Comment: The hydro-mechanical properties of soils were widely recognized as a major factor influencing some key sub-processes of gully erosion, but due to the difficulty of monitoring the infiltration during the gully development, especially in the field. Therefore, this study has important contribution to reveal the influences of different hydro-mechanical properties on gully erosion through a well design monitoring scheme on soil-related properties. But there are a few key questions need be explained clearer and precisely, which may strongly affect the results and conclusion of this study. I suggest major revision right now.

We made a throughout revision for the previous manuscript. **Please see the manuscript with marked changes and accepted changes.**

Table 1. Detailed information of three UAV flights and the digital elevation models

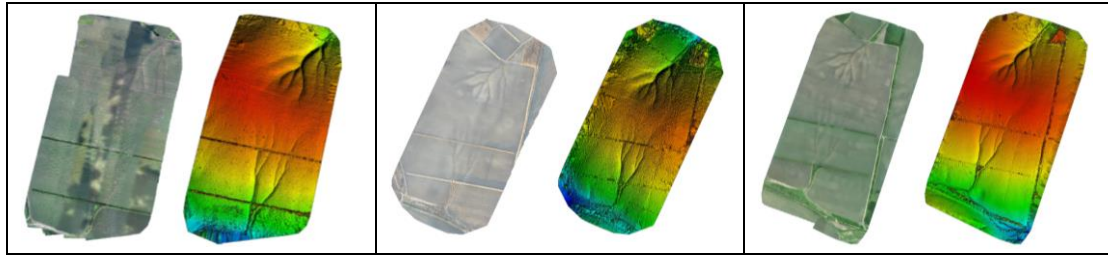
Comment: The authors should give more details about the gully monitoring by the UAV, and the processes to calculate the variation of the gullies, and the accuracy of the monitoring methods. How you dealt with the effects of vegetation on morphological changes of gullies? I saw a lot of plants on your selected gully beds.

The other two reviewers also gave me such comments about the UAV information. We should give a clear description of the UAV information and how we use software (Resisted Pix4D software) to diminish the effect of vegetation on morphological changes of gullies. In the revised manuscript, we added a new table (table 1 in the revised manuscript) to give the detailed information of the UAV and three flights. As our UAV have Real-time kinematic (RTK for abbreviation), the digital elevation models are high-resolution. Besides, we used Pix4D software to deal with the vegetation problem by generating point cloud and filtering tool.

The orthomosaic images and corresponding digital elevation models are shown as follows:

Step 1. We used Pix4D software to process image synthesis and the gully topography producing, which can reallocate the point cloud and filter the points of vegetation layer. As the points of vegetation layer (mainly the grass leaf) is changeable in plant height while the ground point is fixable, the vegetation layer could be filtered out and removed through the filtering tool.

Step 2. Following manual screening to ensure the removal of any residual vegetation layer point clouds, the elevation data was regenerated, yielding a processed Digital Elevation Model (DEM) for the watershed.

Step 3. The erosion mainly occurs in the slope area and the gully bed area. For sites beyond the gully area, the topography change does not consider in our works as these sites are flatten and not in the gully area. Therefore, gully edges were delineated through visual interpretation of RGB optical images, with efforts made to exclude vegetation on the banks to the greatest extent possible.

The DEM was resampled to 0.10 m using ArcGIS 10.8 software. Ground control points were employed to perform local precise registration of the drone aerial imagery within ArcGIS 10.8, thereby minimizing errors in gully delineation. These ground control points were also utilized to enhance the accuracy of three DEMs.

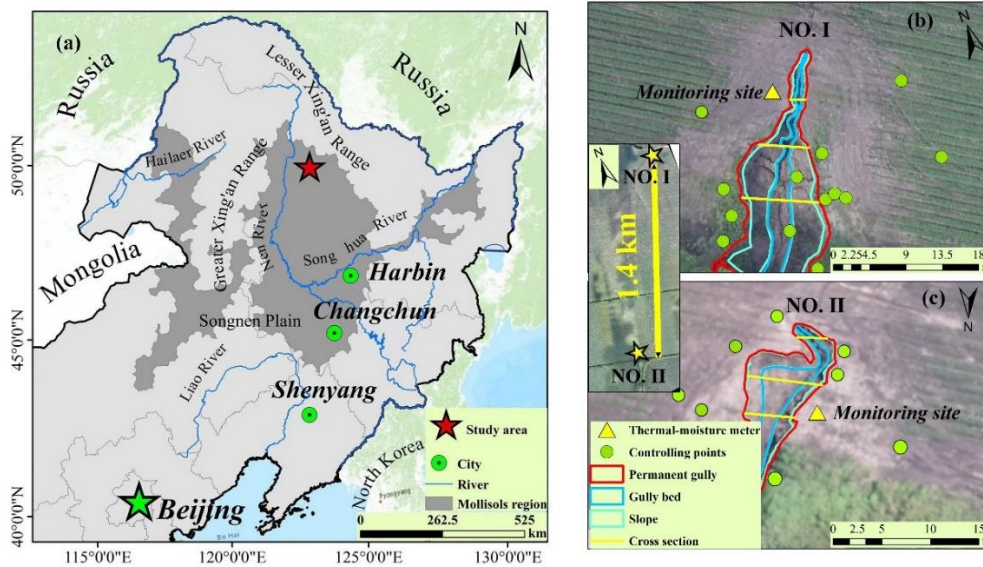
Comment: The authors should clarify the concept of “gully beds” and “slopes” in this manuscript, which I suggest you to marked the location of “gully beds” and “slopes” on figure 1b and c. And to me, the location of “slope” is very difficult to be determined.

Comment: Fig 2 need a figure to show the locations of the two gullies in the catchment.

We should give a clearer symbol to distinguish the gully bed and slope. In the revised manuscript, we improved the quality of figure 1 and figure 2.

The gully head of the two gullies are merely 1.4 km. In the revised process, we updated the location of the two gullies, and texted them in figure 1.

Table 1. Detailed information of three UAV flights and the digital elevation models

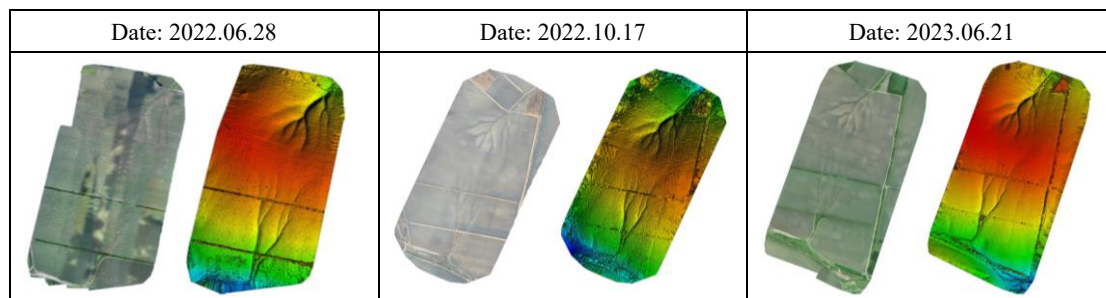
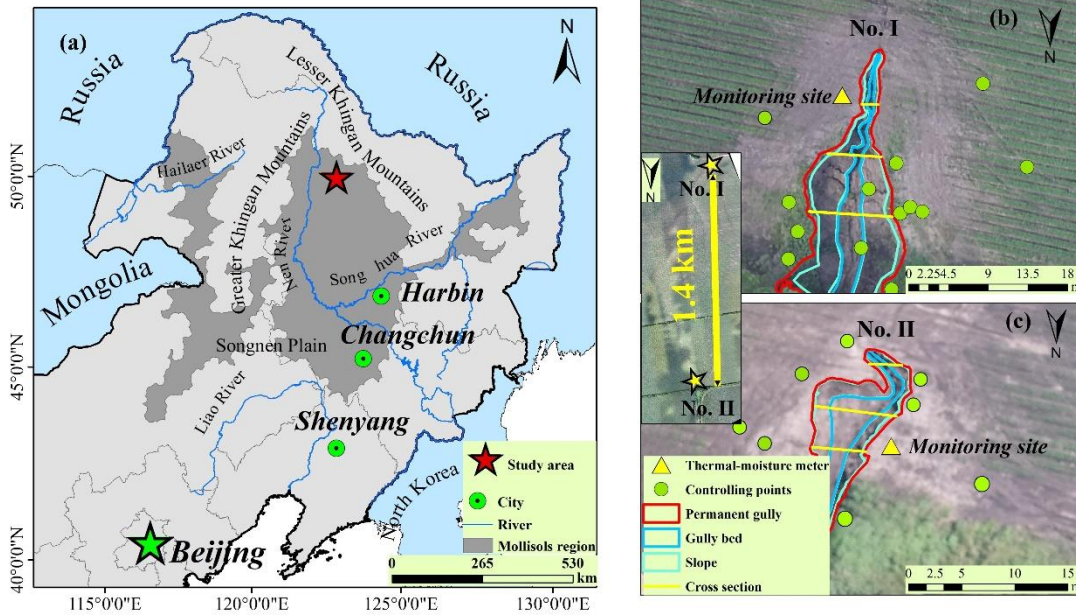
Comment: The second paragraph of section 3.1: more details about the gully monitoring are required: control plates were only applied to check the accuracy of the UAV DSMs, or also as the ground control points to improve the accuracy of DSMs? Which software you used to produce the DSMs? What about the flight height and the overlaps of photos? How to reduce the influences of the vegetation in gullies.

The ground control points (GCPs) offer reference points enabling photogrammetry software to more accurately calibrate camera positions and orientations, as well as better

align and georeference aerial images. This step is crucial for ensuring the accuracy and correct spatial referencing of the DEM, particularly in applications requiring high-precision terrain modeling. We should give a clear description of the UAV information and how we use software (Resisted Pix4D software) to diminish the effect of vegetation on morphological changes of gullies. In the revised manuscript, we added a new table (table 1 in the revised manuscript) to give the detailed information of the UAV and three flights. As our UAV have Real-time kinematic (RTK for abbreviation), the digital elevation models are high-resolution. Besides, we used Pix4D software to deal with the vegetation problem by generating point cloud and filtering tool.

Step 1. We used Pix4D software to process image synthesis and the gully topography producing, which can reallocate the point cloud and filter the points of vegetation layer. As the points of vegetation layer (mainly the grass leaf) is changeable in plant height while the ground point is fixable, the vegetation layer could be filtered out and removed through the filtering tool.

Step 2. Following manual screening to ensure the removal of any residual vegetation layer point clouds, the elevation data was regenerated, yielding a processed Digital Elevation Model (DEM) for the watershed.

Step 3. The erosion mainly occurs in the slope area and the gully bed area. For sites beyond the gully area, the topography change does not consider in our works as these sites are flatten and not in the gully area. Therefore, gully edges were delineated through visual interpretation of RGB optical images, with efforts made to exclude vegetation on the banks to the greatest extent possible.

The DEM was resampled to 0.10 m using ArcGIS 10.8 software. Ground control points were employed to perform local precise registration of the drone aerial imagery within ArcGIS 10.8, thereby minimizing errors in gully delineation. These ground control points were also utilized to enhance the accuracy of three DEMs.

Fig. 4. Differences in the erosion per unit area for gully bed and over-steepen slope

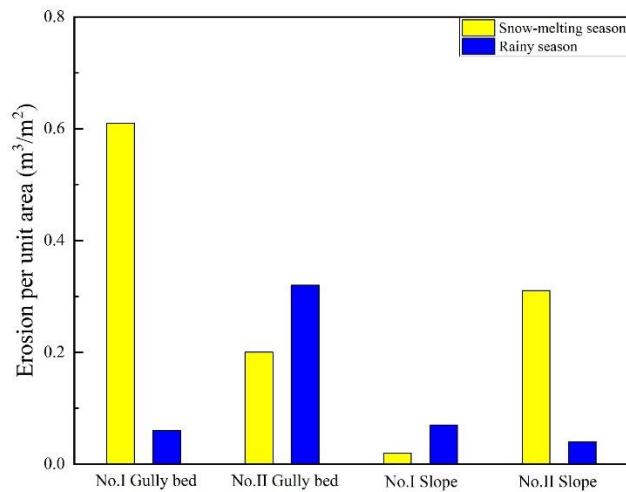
Comment: Fig 4. "Areal erosion intensity" is very confusion, I guess your means the volumetric changes divided by the area of the locations. If so, just "Erosion per unit area" is better. Also in the text.

We modified the areal erosion intensity to erosion per unit area in figure 4 and figure 11. Also, all of the "areal erosion intensity" in the text (including the figure caption) were modified to "erosion per unit area".

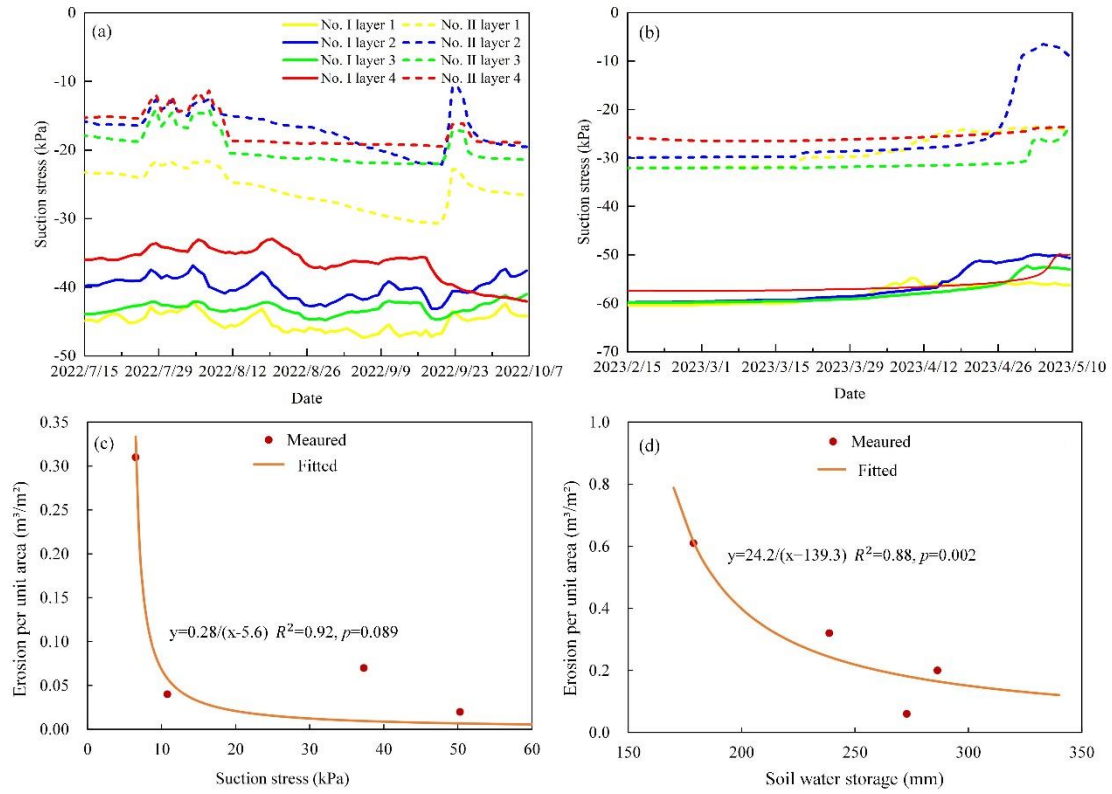
Comment: The erosion of "slope" was correlated with suction stress is OK to me (Fig 10.c), but the "gully bed" normally considered to eroded surface runoff, and how to explain the influences by water storage need be more clear.

Erosion of gully bed positively relates to surface runoff. In a given rain event, the more surface runoff, the less the water storage. In fact, water storage and the runoff depth were approximately equal to the rainfall depth. Consequently, the erosion per unit area of the channel bed was inversely proportional to the water storage.

In the revised manuscript, figure 11c (as figure 10c in previous manuscript) sufficient prove that the low suction stress (or high soil moisture) corresponds to the high slope erosion or intensive gravitational mass movement. Figure 11d describes the stored

water with the erosion. The more the water is stored in rain events, the less the runoff a catchment will produce.
